# Brook Federal TB NENE Sec. 30 T17S R32E Lease NMLC060199B

Brook Federal #3 Battery NMLC060199B, Sec 30, NENE, T17S, R32E July 18, 2014

### Conditions of Approval (COAs)

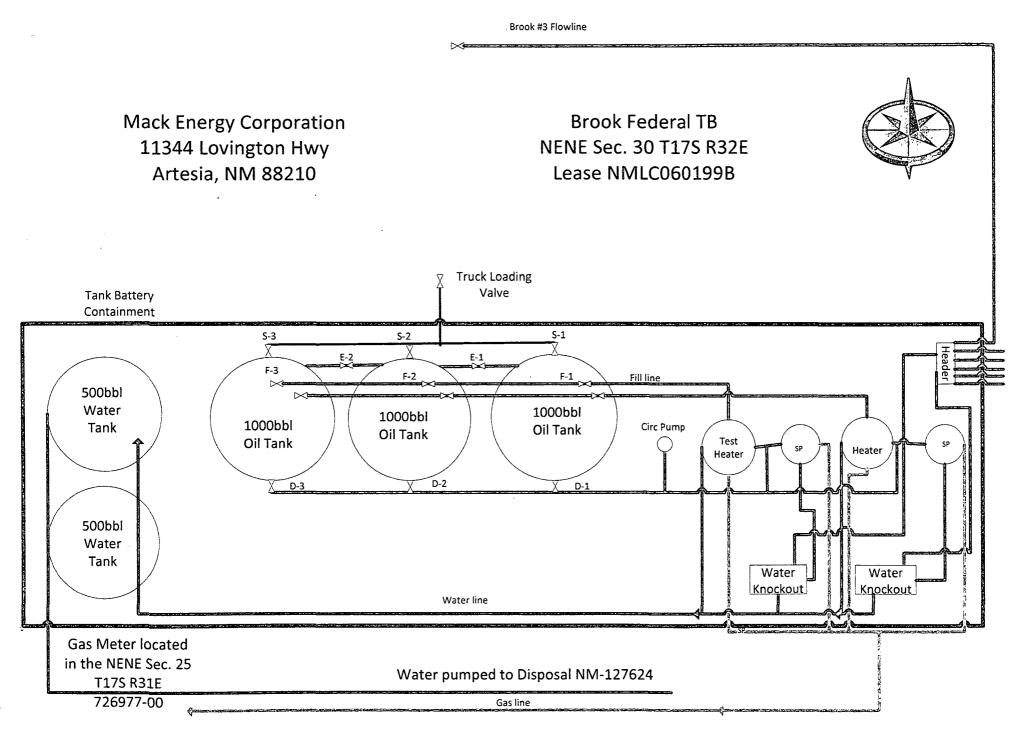
- 1. All oil sales will be conducted as per Onshore Order #4, III, B, C & D. The use of Tank Logix system for the sales of oil is not approved. The use of Tank Logix system for daily pumpers reading is approved.
- 2. The installation of Tank Logix system is not approved if it affects the tank integrity in any way. Tank equipment shall be installed and maintained as per Onshore Order #4, III, C, 1 (Sales Tank Equipment) and API requirements. The Installation of this system must not prevent the oil storage system from holding Pressure/Vacuum.
